DEVIATION REQUEST (Attach diagrams, figures, and other documentation to clarify request)

A deviation from the standards of the ECM in **Chapter 2.2.5.E** is requested.

RETREAT AT PRAIRIE RIDGE
PRELIMINARY PLAN PARCEL
JOB NO. 1305.00-09
MARCH 21, 2024
PAGE 1 OF 3

RETREAT AT PRAIRIERIDGE FILINGS 1-3

RETREAT AT PRAIRIERIDGE FILINGS 1-3			
PRELIMINARY PLAN			
FILING 1 & 2			
DESIGNED BY	MAW	SCALE	DATE
DRAWN BY	MAW	(H) 1" = 60'	SHEET 6 OF 28
CHECKED BY	(V) 1" = N/A	JOB NO.	1305.10

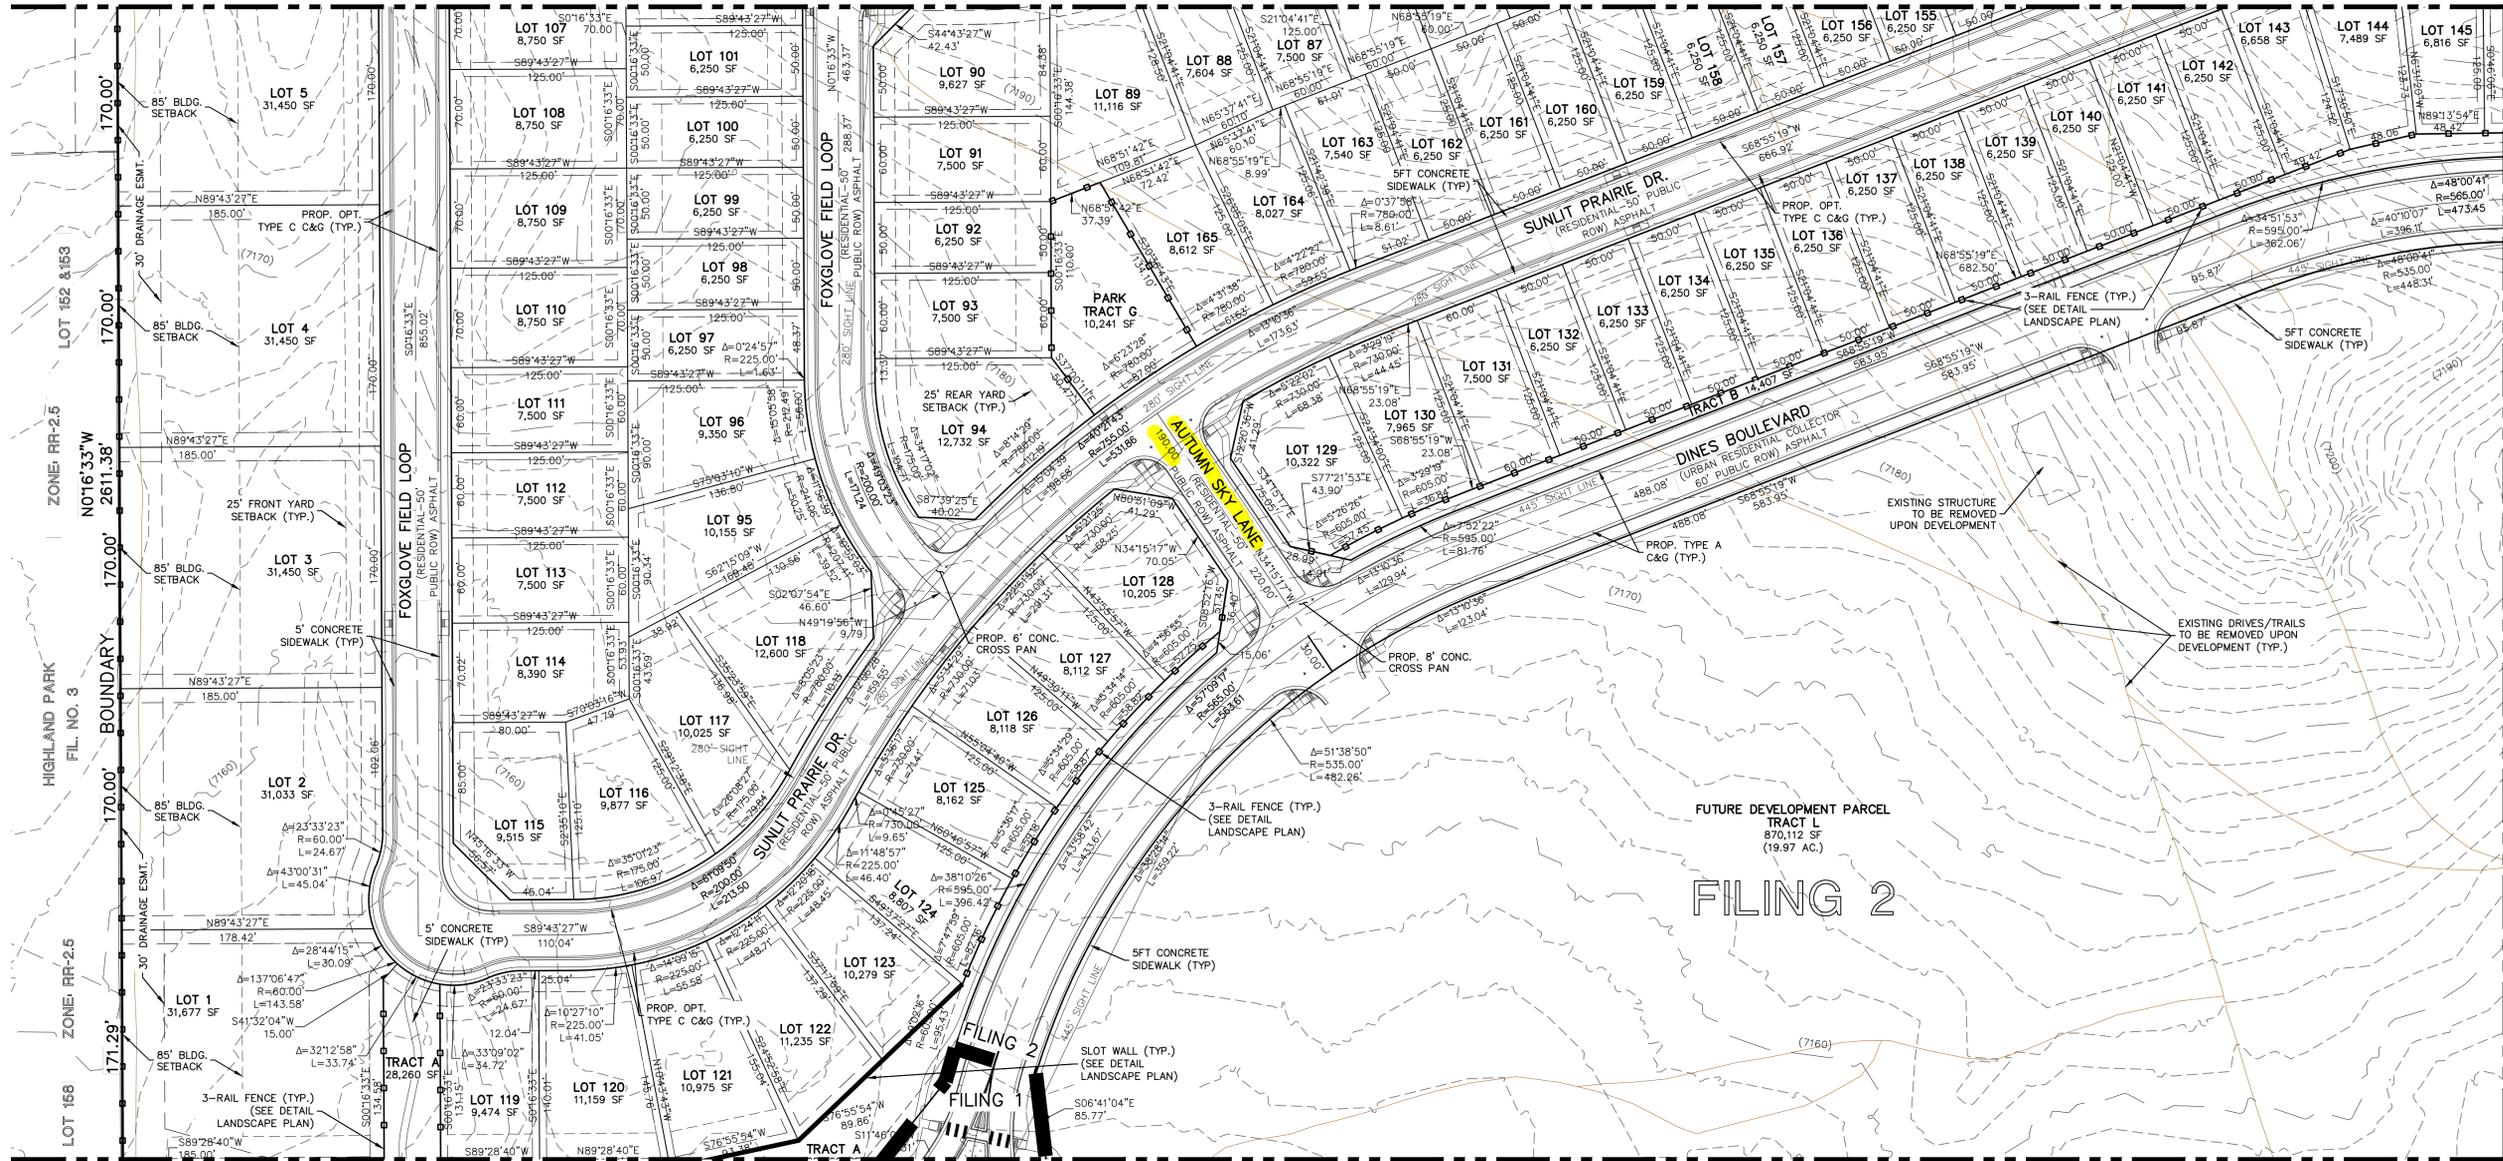
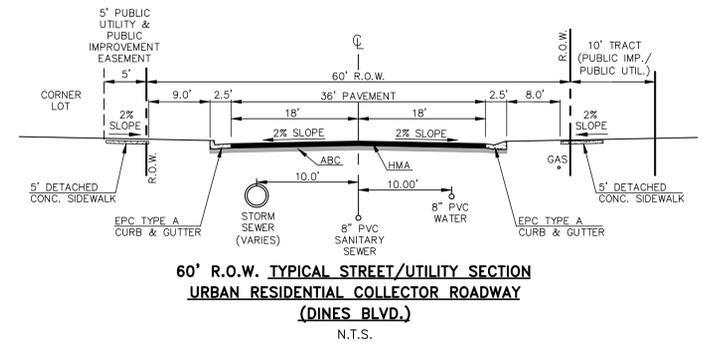
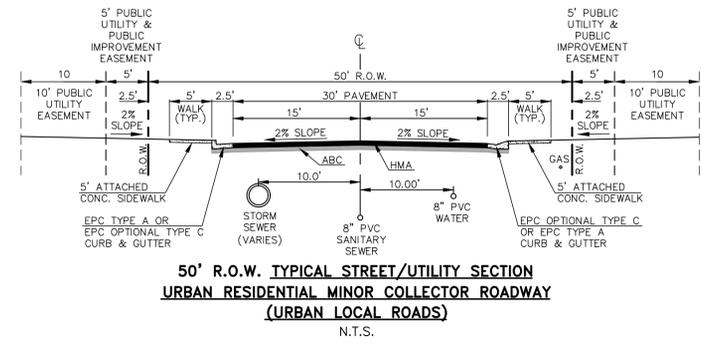
An urban local intersection is planned 190' away from collector road (CL to CL) rather than the required 200'. This design is based on a standard single family lot depth of 125' along with a 10' tract adjacent to the collector road. (Reference the Preliminary Plan – Autumn Sky Lane connection between Dines Blvd. and Sunlit Prairie Dr.)

An urban local intersection is planned 282' away from a rural arterial (ROW to CL) rather than the required 330'. This design again is based on a standard single family lot depth of 125' along with a park tract adjacent to the arterial road. (Reference the Preliminary Plan – Dines Blvd. connection between Wheatfield Walk Lane and Vollmer Road)

The proposed alternative is to maintain a reasonable lot depth of 125' along with a 10' open space tract adjacent to the collector roadway as required for double frontage lots. This CL-CL distance between intersections then equals 190' rather than the 200' criteria.

The proposed alternative is again to maintain a reasonable lot depth of 125' along with a park tract between the lots and Vollmer Road as required by the 50' buffer and park as shown on the approved Jaynes Property Sketch Plan (SKP225) This ROW-CL distance between intersections then equals approximately 282' rather than the 330' criteria. Incidentally, the CL-CL distance equals 332'.

In urban single family developments it is standard practice to have typical lot depths or 100'-120'. In this portion of the project, the lots are double frontage lots and an additional open space tract (10' in this case) is planned adjacent to the collector roadway. Thus, the 125' lot depth and 10' tract determined the 190' CL-CL spacing. (Reference the Preliminary Plan – Autumn Sky Lane connection between Dines Blvd. and Sunlit Prairie Dr.)

The southern portion of the project has a similar condition, however, there is a park planned between the lots and Vollmer Road. The 125' lot depths and the varying width of the park in this area determine the 282' ROW-CL spacing. (Reference the Preliminary Plan – Dines Blvd. connection between Wheatfield Walk Lane and Vollmer Road)
